RESULTS OF PUBLIC CONSULTATION

REPRESENTATIVE COMMENTS RESULTING FROM PUBLIC CONSULTATION

BP Bezaire Partners Planners, Landscape Architects <small>3514 Walker Rd., Unit 1A Windsor, ON N8W 3S4 p: 519 995 6844 f: 519 995 4088 gbezaire@bezaire.ca</small>	PROJECT: GANATCHIO TRAIL EXTENSION	CLIENT: Tecumseh <small>ONTARIO • CANADA</small>	DRAWING TITLE CONCEPT PLAN	DATE: JUNE, 2018	SHEET
				SCALE: 1:500 @ 11 X 17 1:250 @ 22 X 34	LA-C-13
				DRAWN BY: ML, GDB	1267 Concept R4

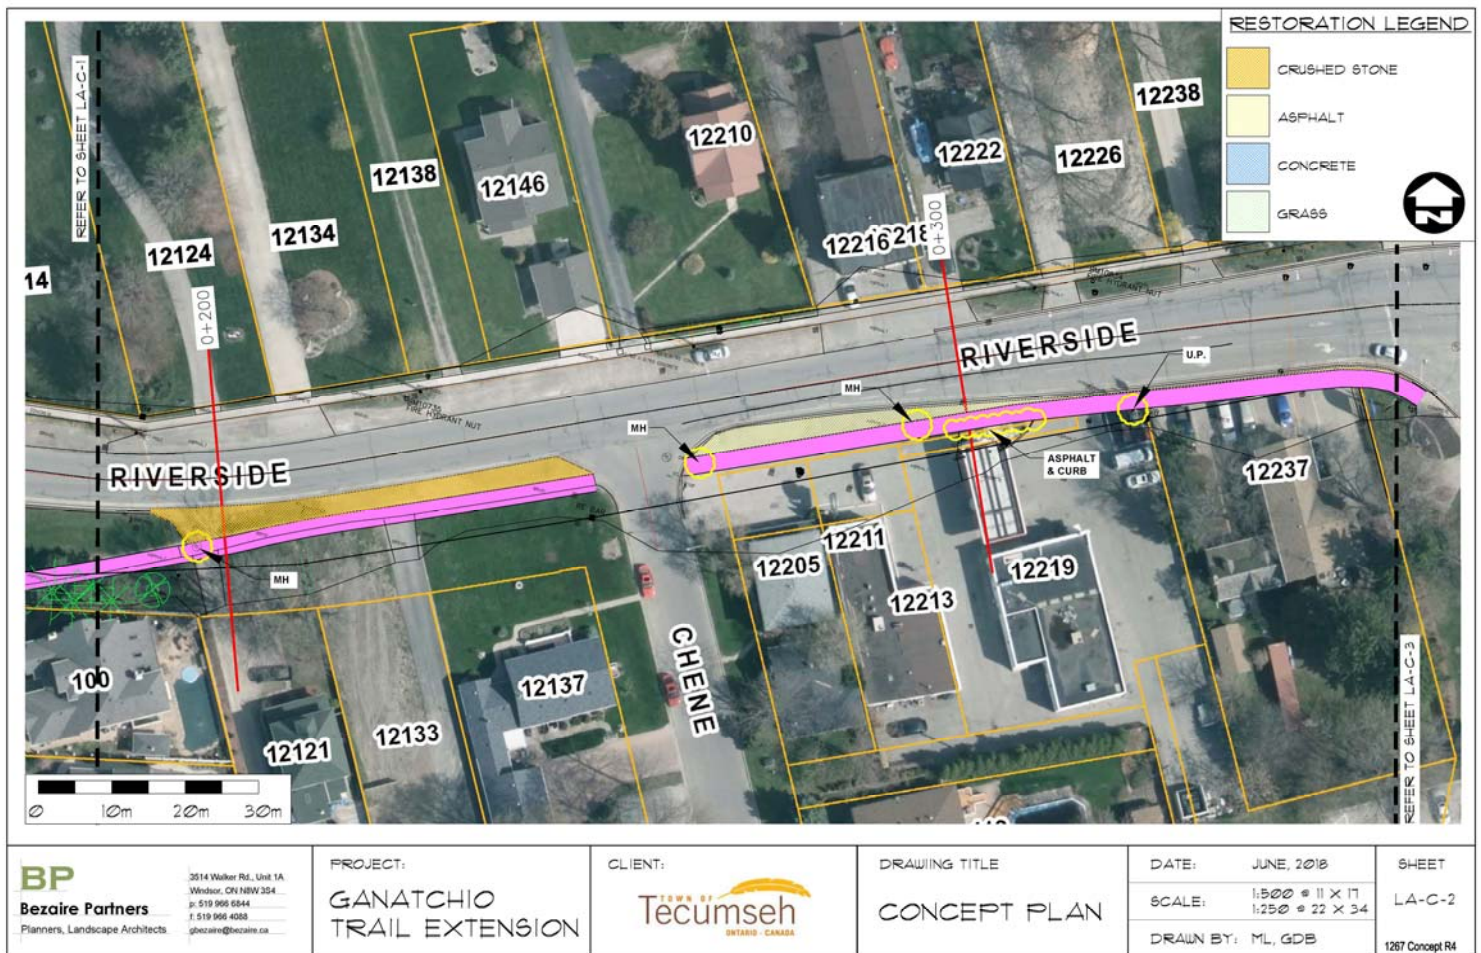
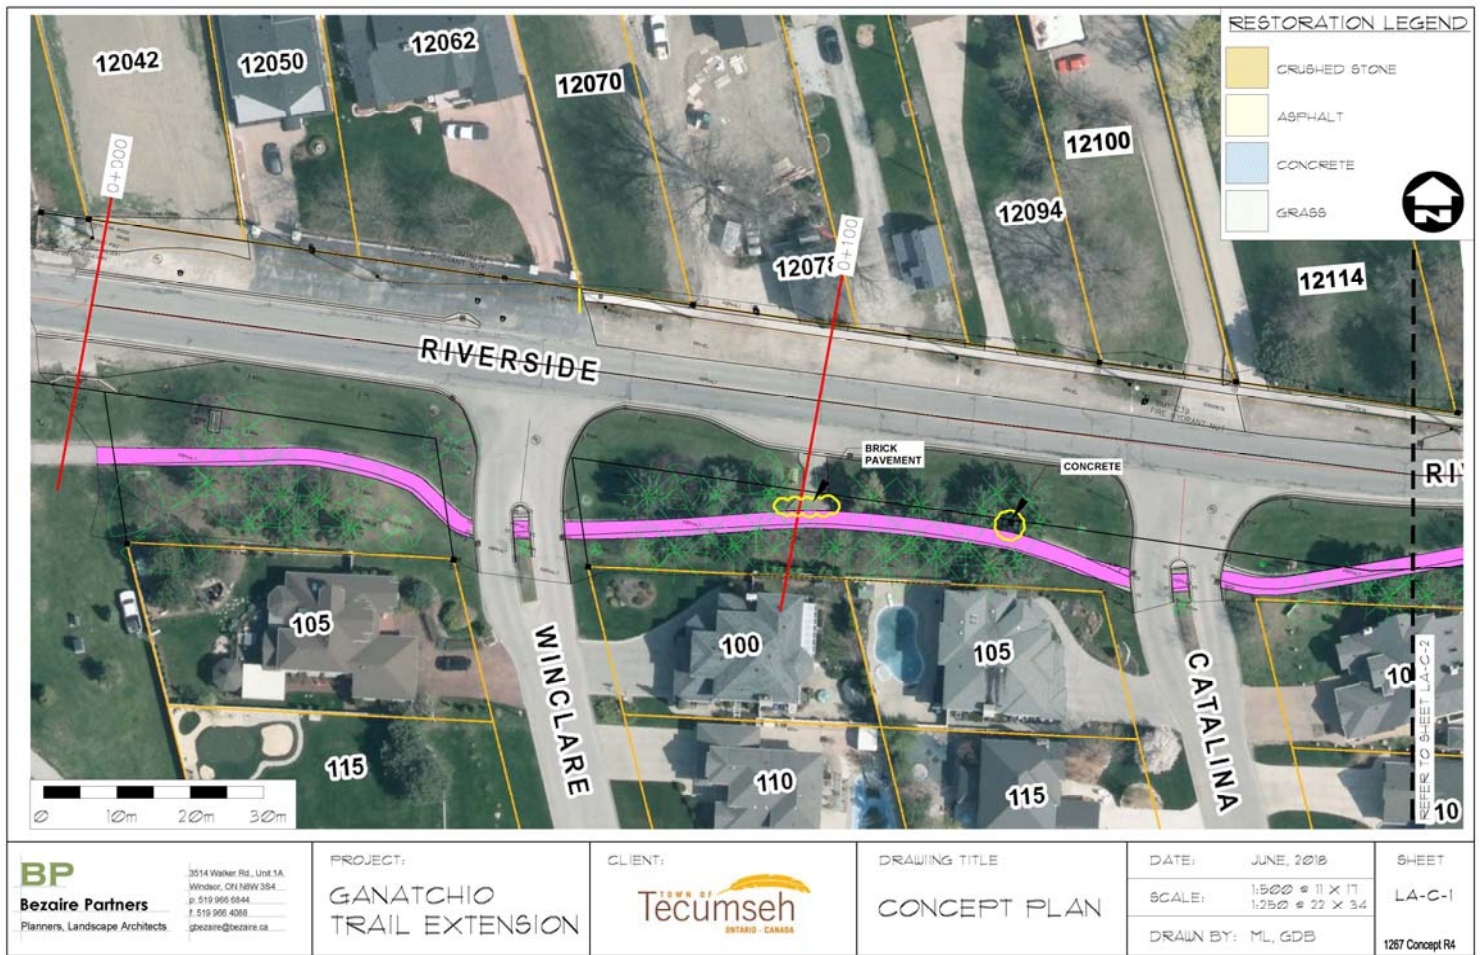
Comment: While the trail is slightly longer on the south side, there are more construction related issues on the north side. The relocation of fire hydrants and catch basins for example can be quite expensive. Since the Town prefers to not remove trees, there are seven locations on the north side where the width of the trail will be compromised (reducing from 2.5m wide to 1.2m) to preserve the trees. Even then, it is likely that the trees will begin to decline due to the impact of construction and eventually will have to be removed. In each case, the existing trees are presently in good condition.

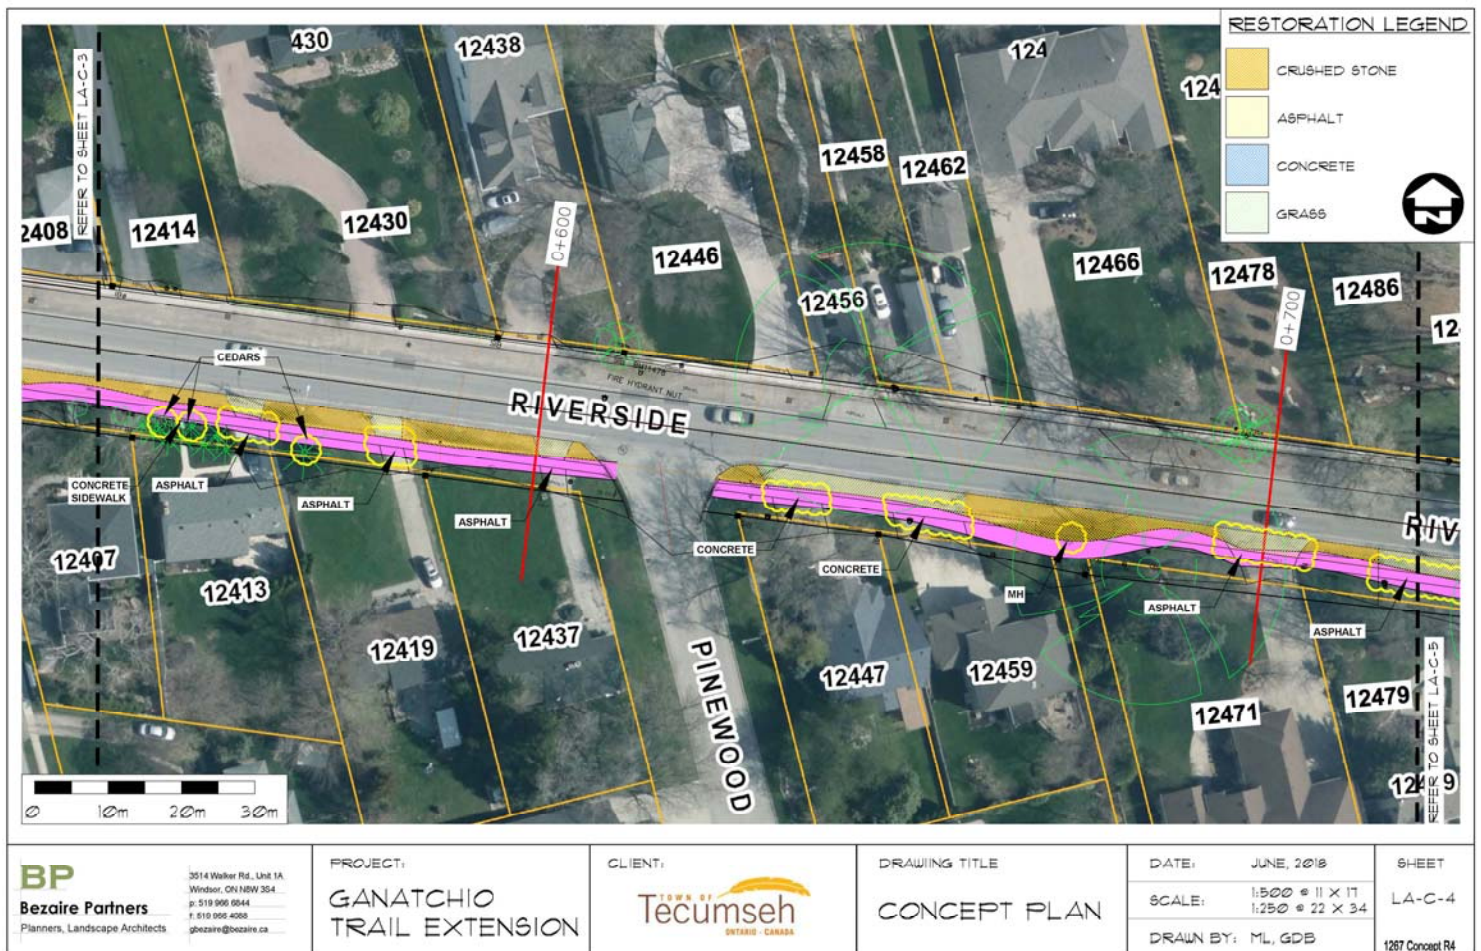
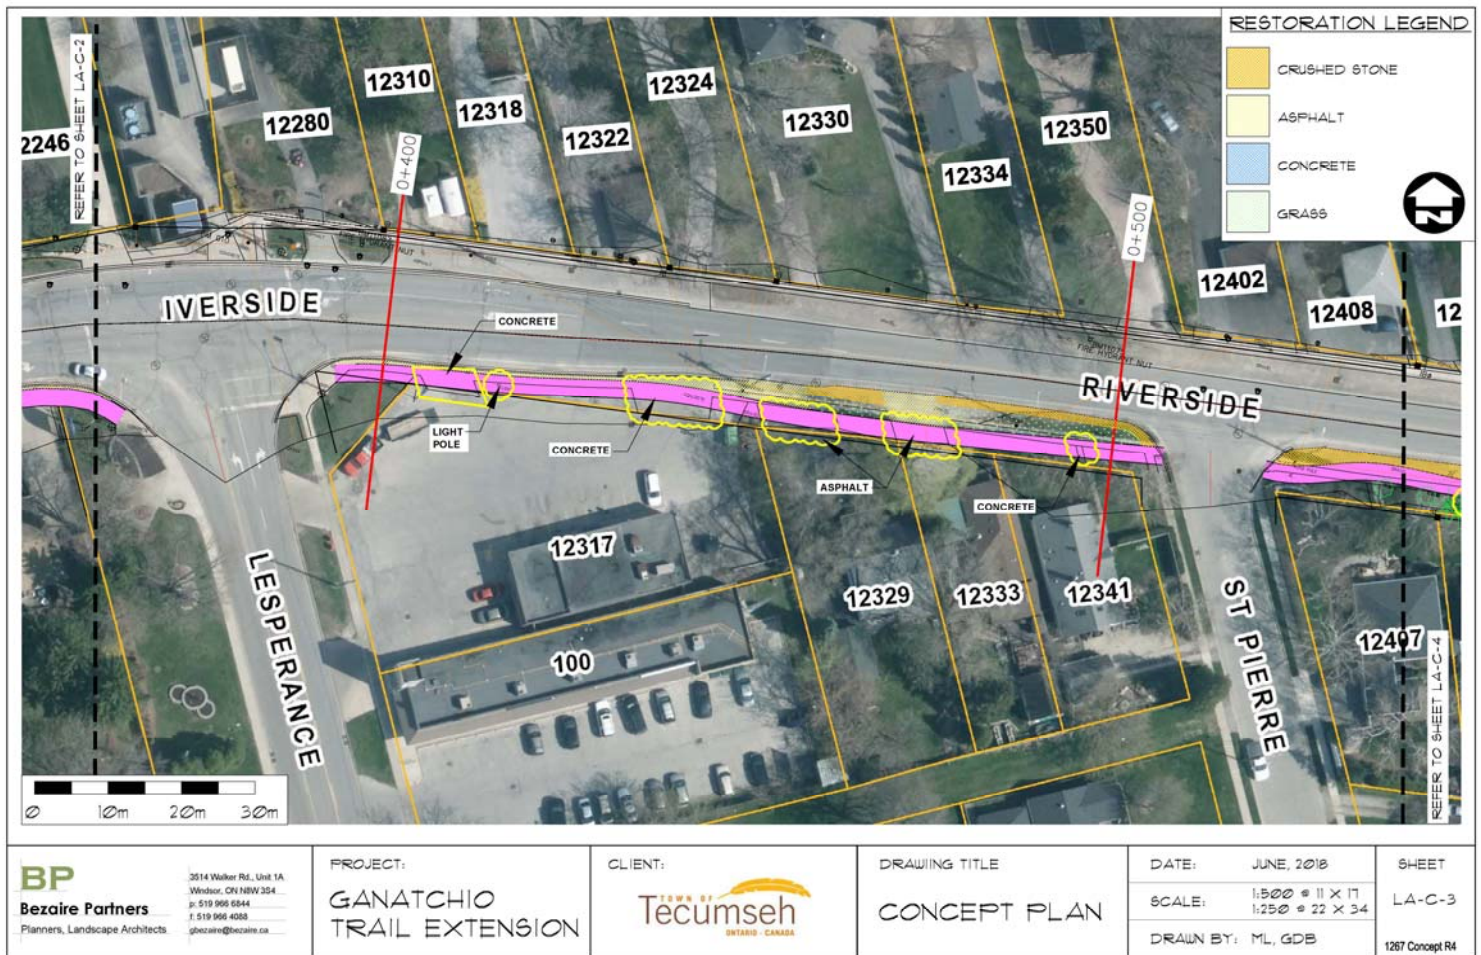
While we will have to remove two trees on the south side, these trees are under existing overhead wires and the heads have been severely trimmed. They are in poor condition and should be removed.

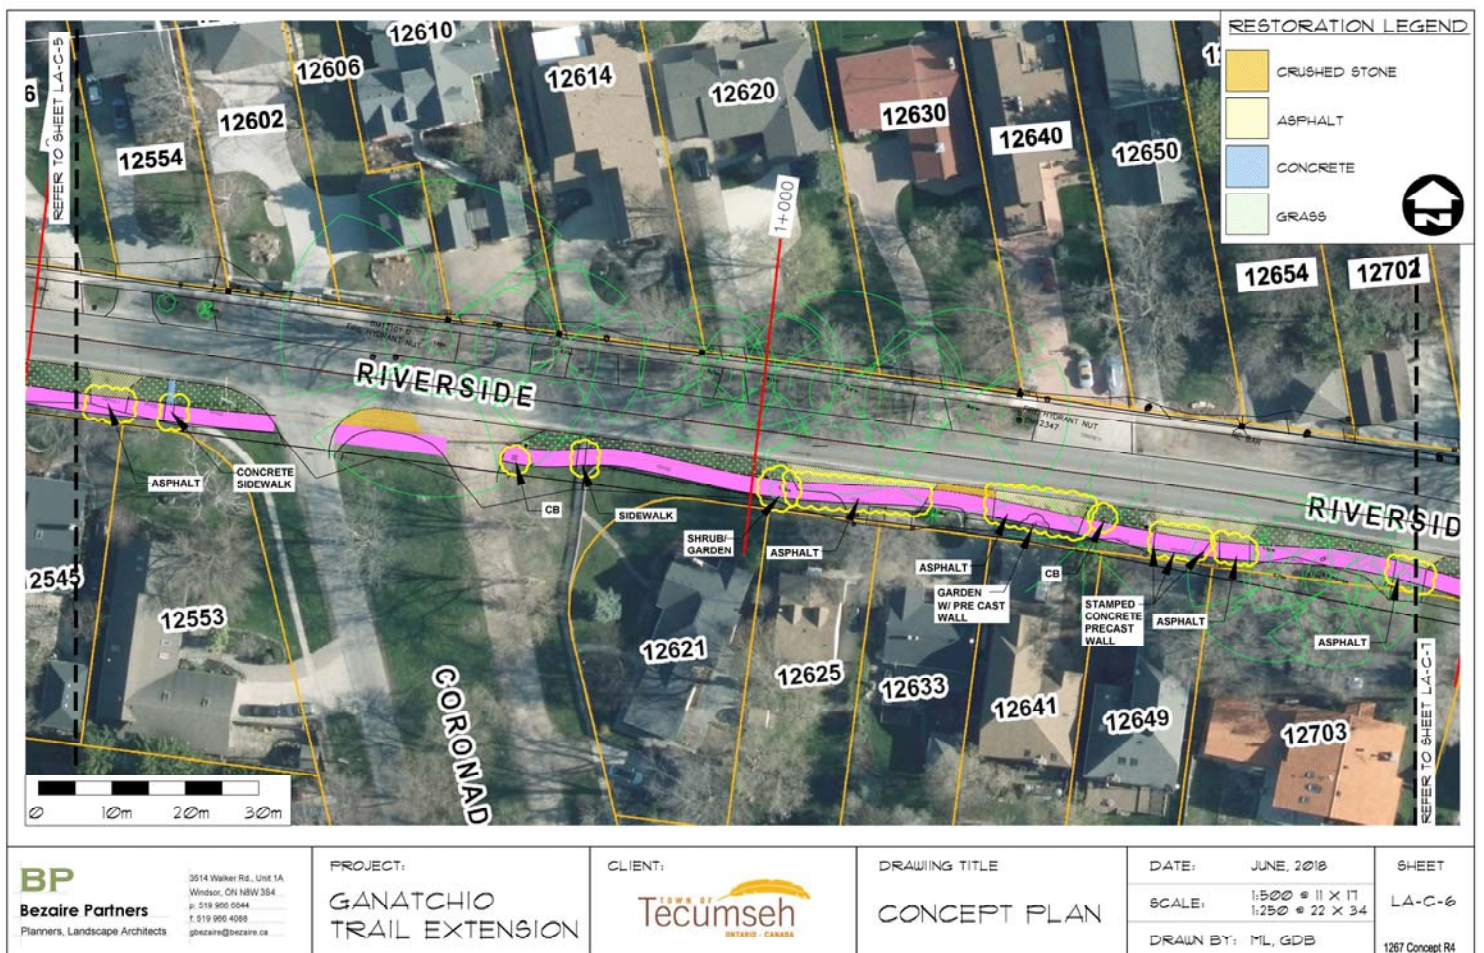
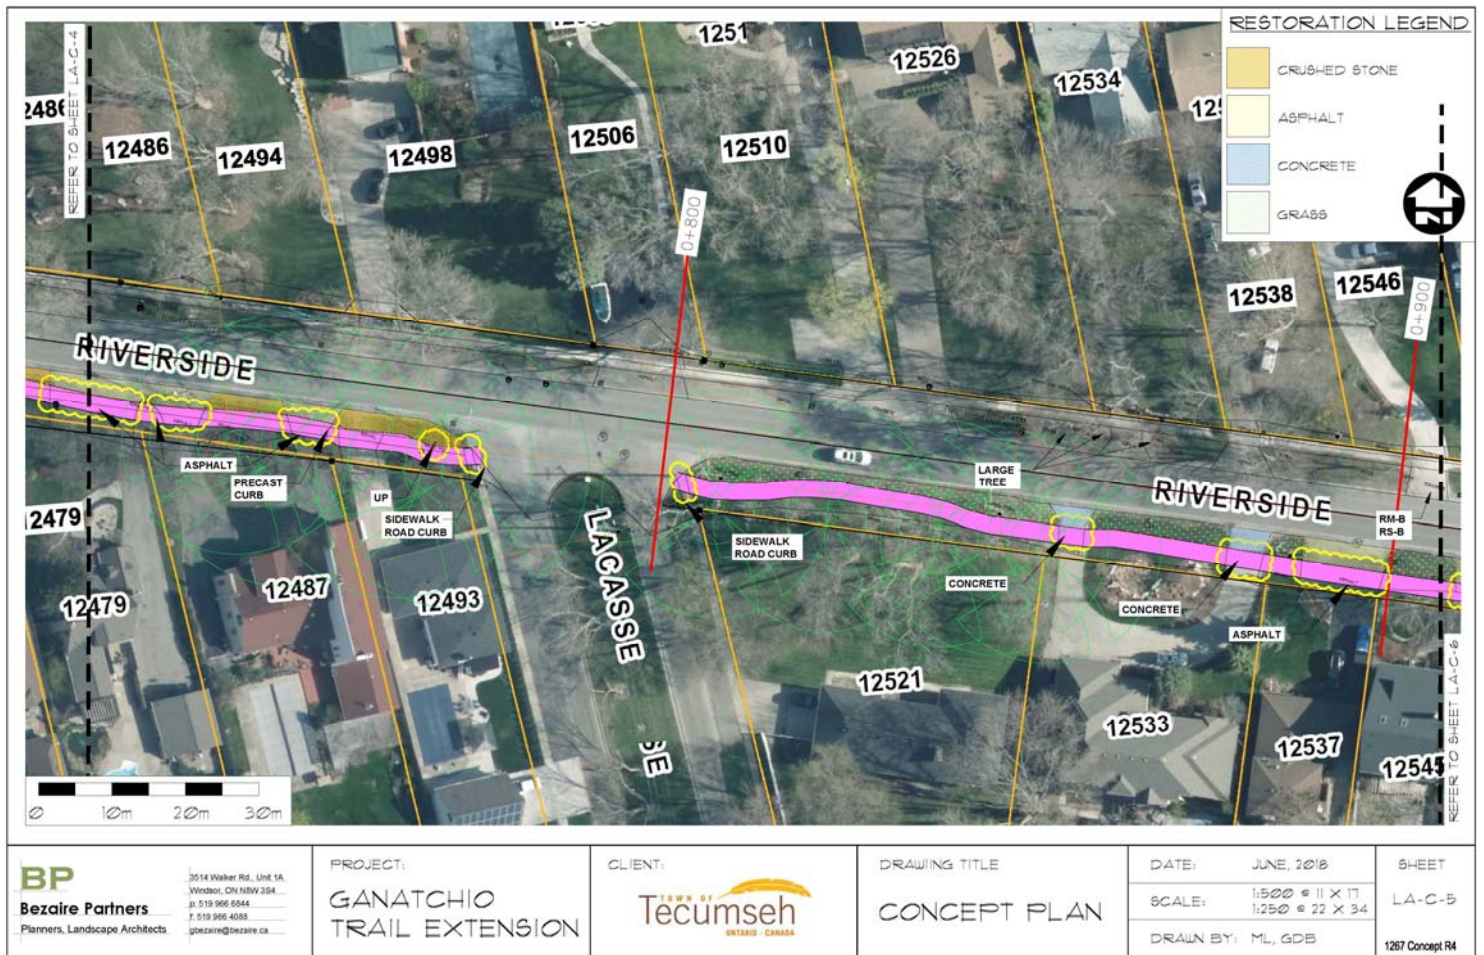
There is approximately 25% more driveway crossings on the north side, but no road crossings.
